★ Revision

B25001976

SFD/ CONSTRUCT 12' 16' PORCH WITH EASY BREEZE WINDOWS

14701 Triadelphia Rd

PLOT DIAGRAM LO
 PAS: LRTI. ST. GREG. I
 ZEIGLER WORK 202 &
 HOME 410 73
 5968-7 JUR
 UT LANE CO.
 TA. MD. 211

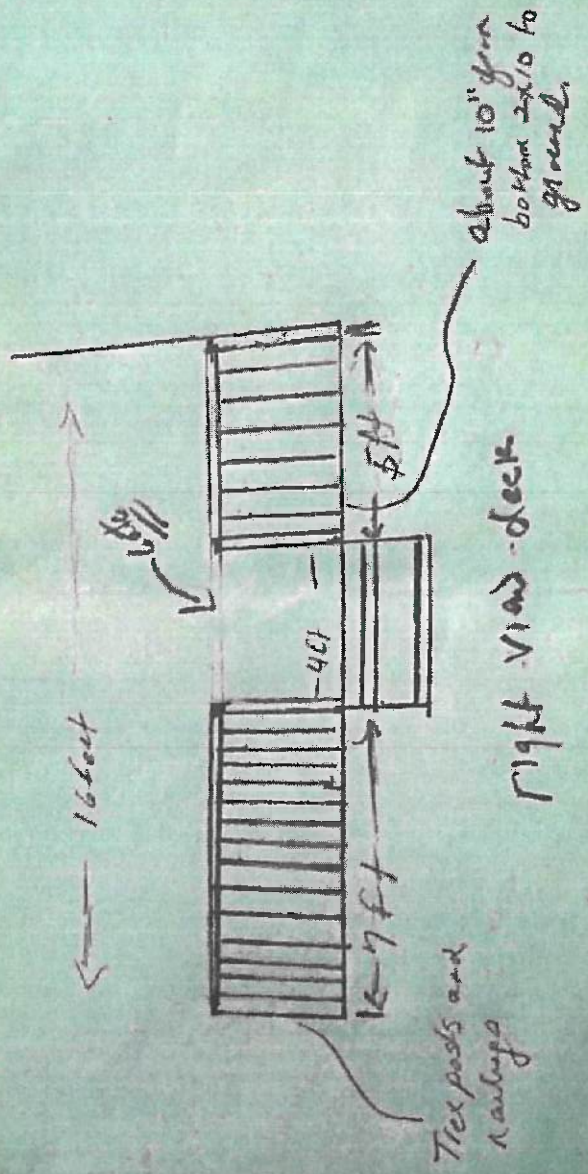
Good afternoon. The site plan submitted with the building permit is not clear. I am unable to see where the proposed structure is being proposed. Please provide a clearer drawing with proposed structure highlighted meeting required setbacks (see attached). I've attached the septic record for this property in case you need to refer to it (see attached).

Note
 13' 4" as a porch
 10' 9" as a deck
